Sheet: /
File: power_supply.sch

Title: CommCube Power Supply

Size: USLetter	Date: 2021-09-26	**Rev: 1.01**
KiCad E.D.A. kicad 5.1.9+dfsg1-1		Id: 1/1

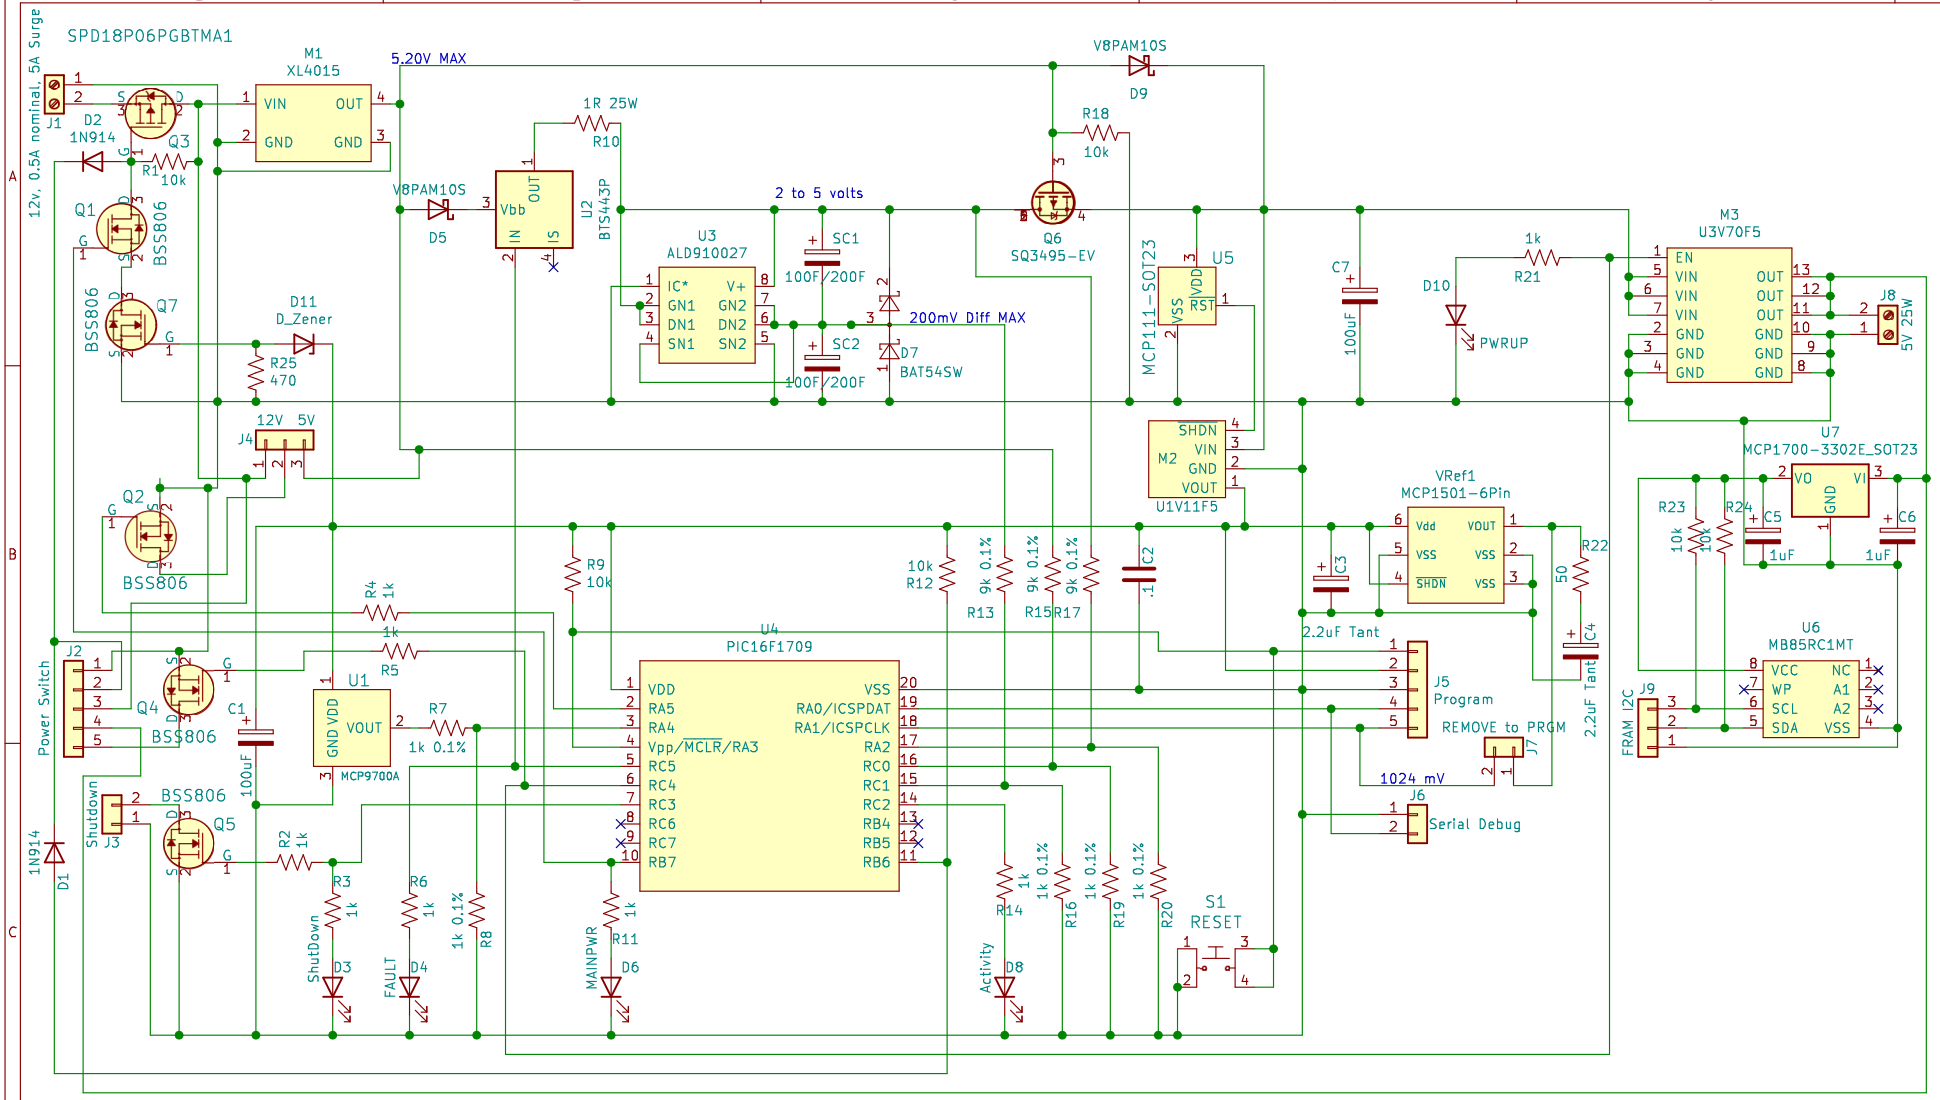
Validated footprints
Added C7
Added Q7 and D11 to monitor PIC power. Below 3v3 will
not allow splurious signals to bootstrap Q3
